Subject: **11 Seal Cove Road, Site Plan**

This is to advise that we have reviewed the following documents pertaining to the proposed raze and rebuild of the dwelling at the subject site:

DETAILS

CULTEC RECHARGER 100 HD
NOT TO SCALE

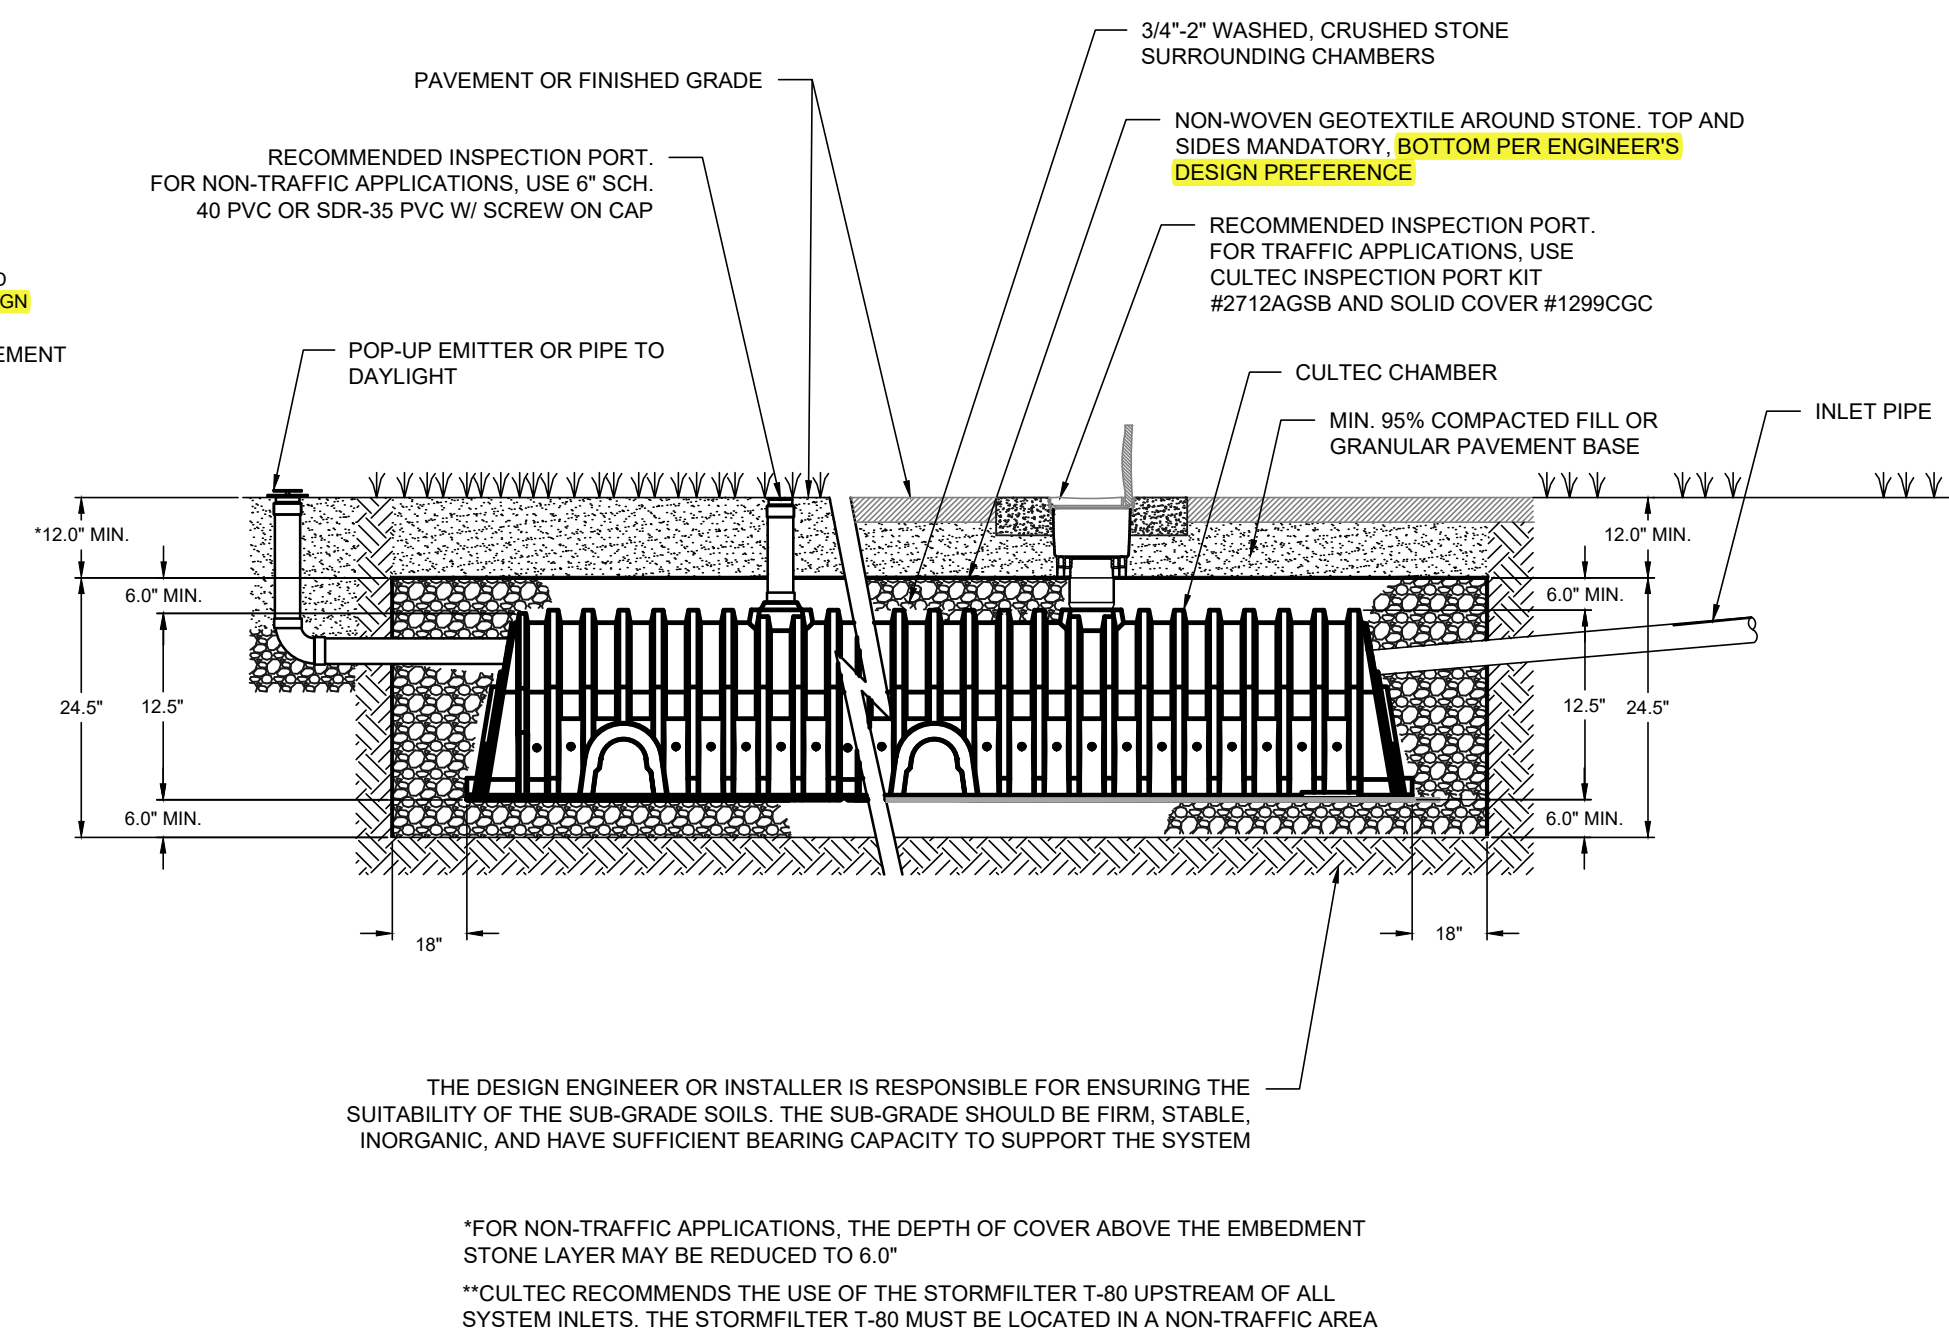
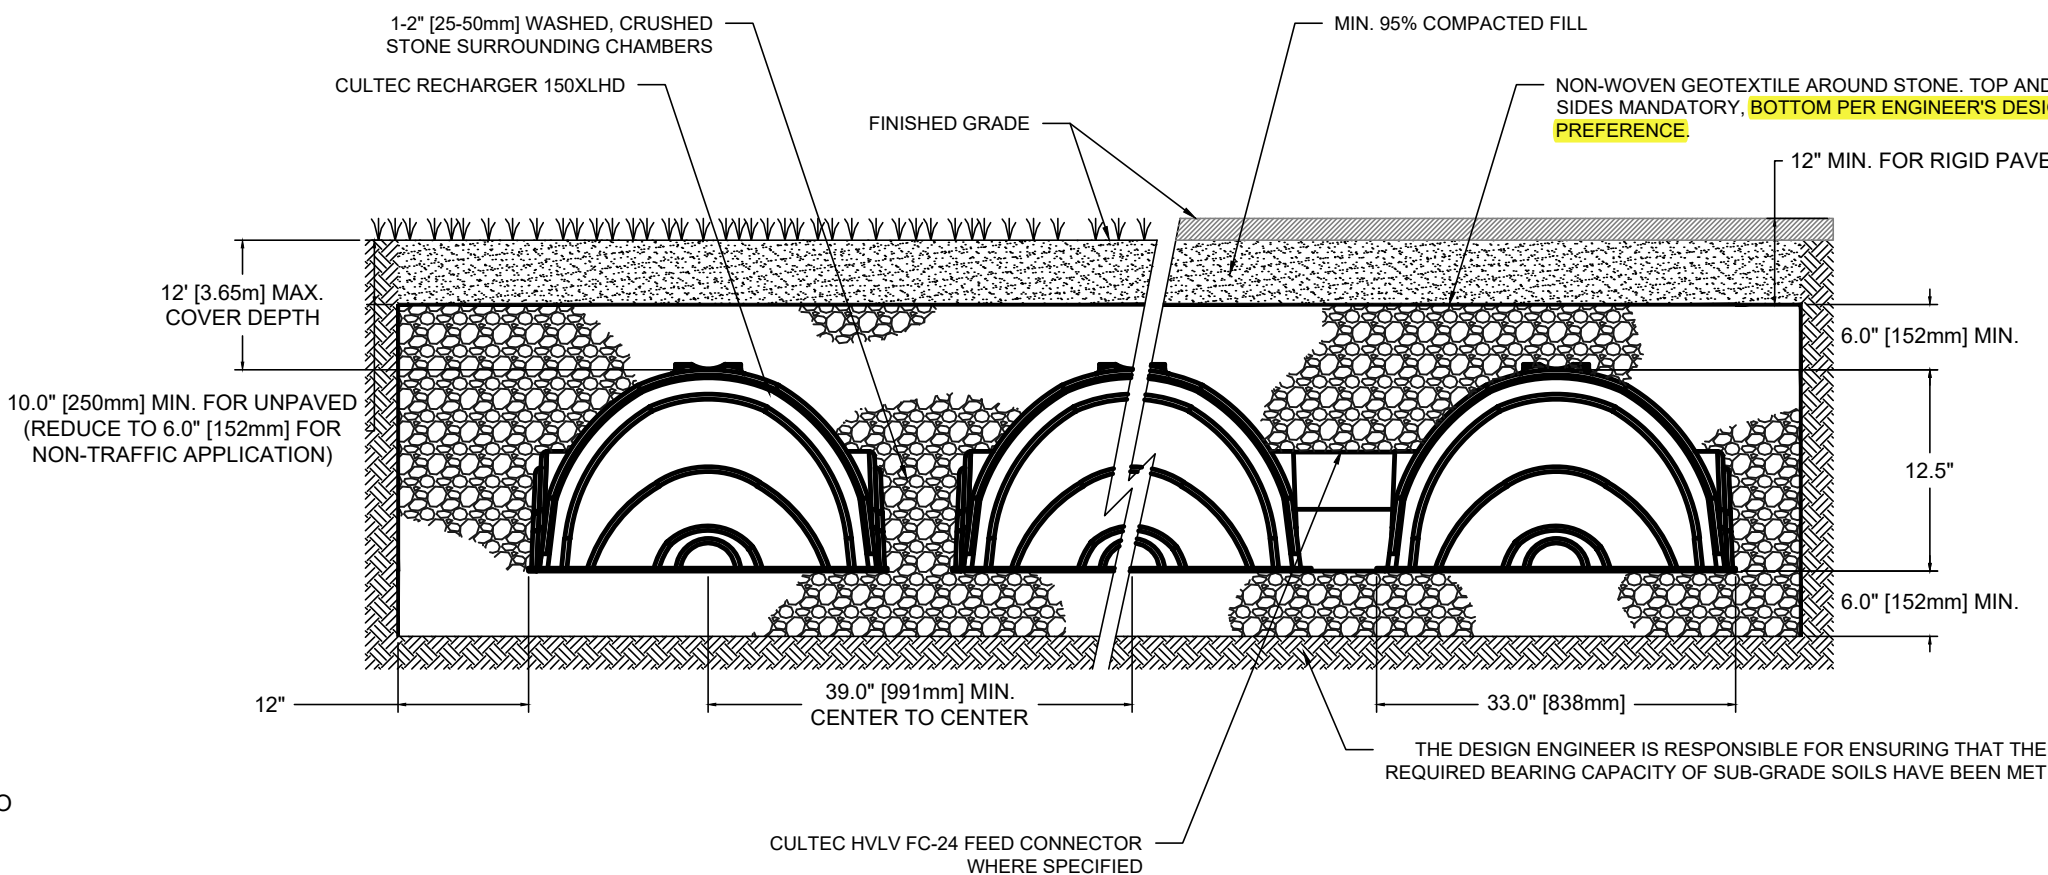
2. The Cultec Recharger 150 XLHD detail on Sheet C-2 specifies filter fabric to be mandatory on the top and sides of the systems and along the bottom per the design engineer's preference. We do not recommend filter fabric along the bottom of the systems. **The notes still state "bottom per engineer's design preference." See attached highlighted plan.**

3. Inspection ports are shown on the chambers with inlet pipes. We recommend inspection ports also be located on the chambers with outlet pipes. **Addressed – the inspection ports are now shown on each chamber with an inlet or outlet pipe.**
